Well Name: RUTHLESS 11 FED COM	Well Location: T25S / R32E / SEC 11 / TR B / 32.1505249 / -103.6453163	County or Parish/State: LEA / NM
Well Number: 750H	Type of Well: OIL WELL	Allottee or Tribe Name:
Lease Number: NMNM110835	Unit or CA Name:	Unit or CA Number:
US Well Number: 3002548879	Well Status: Drilling Well	Operator: EOG RESOURCES INCORPORATED

Notice of Intent

Type of Submission: Notice of Intent	Type of Action: APD Change
Date Sundry Submitted: 07/18/2022	Time Sundry Submitted: 11:54
Date proposed operation will begin: 07/21/2022

Procedure Description: EOG respectfully requests an amendment to our approved APD for this well to reflect the following changes: Update casing and cement program to current design. Change intermediate casing shoe depth/formation to Wolfcamp.

Revised Wellbore

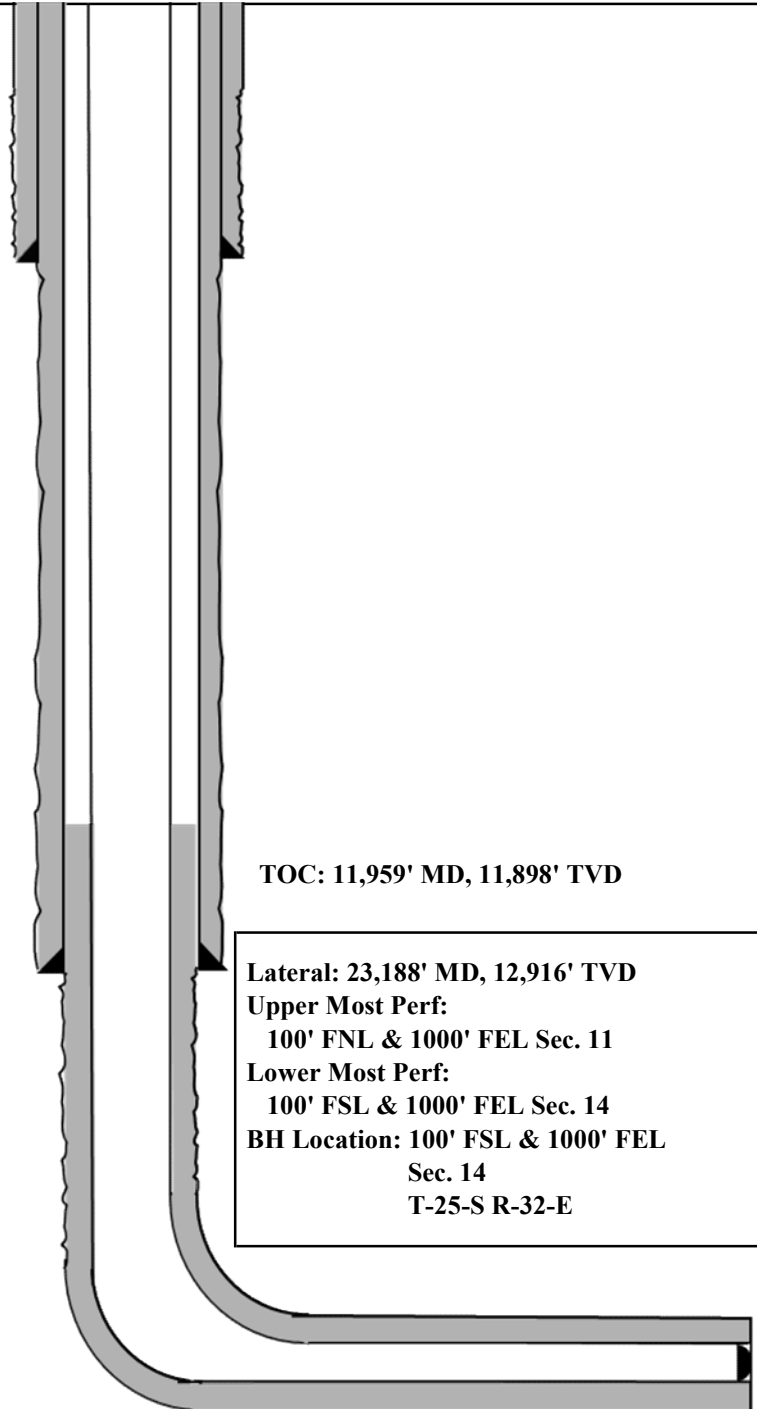
Bit Size: 12-1/4"
9-5/8", 36#, J-55, LTC,
@ 0' - 940'

Bit Size: 8-3/4"
7-5/8", 29.7#, HCP-110, FXL,
@ 0' - 12,460'

Bit Size: 6-3/4"
5-1/2", 20#, P110-EC, DWC/C IS MS,
@ 0' - 11,960'
5-1/2", 20#, P110-EC, Vam Sprint SF,
@ 11,960' - 12,460'
5-1/2", 20#, P110-EC, DWC/C IS MS,
@ 12,460' - 23,188'

Proposed Wellbore

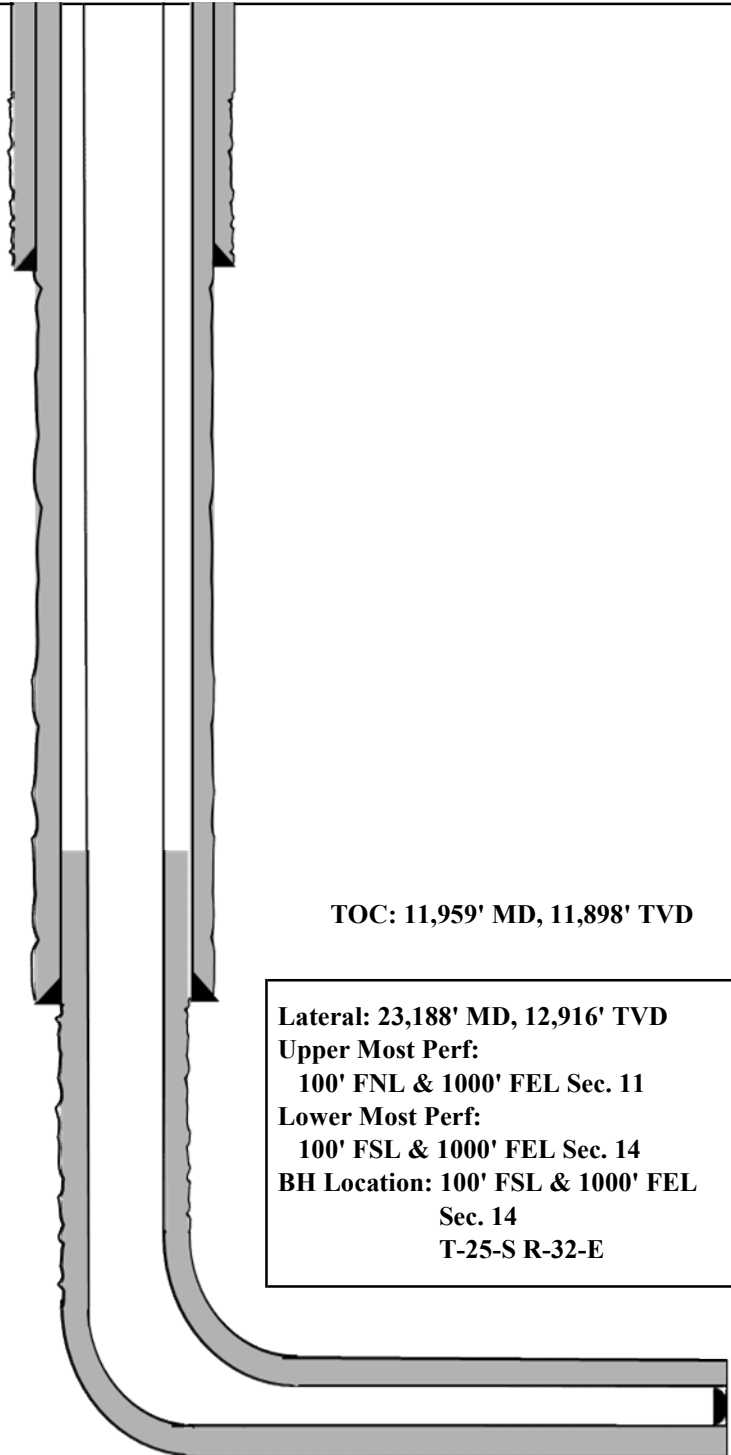
Bit Size: 13"
10-3/4", 40.5#, J-55, STC,
@ 0' - 940'

Bit Size: 9-7/8"
8-3/4" 38.5#, P110-EC, Vam Sprint-SF,
@ 0' - 12,459'

Bit Size: 7-7/8"
6", 24#, P110-HP, Eagle SFH SC,
@ 0' - 23,188'
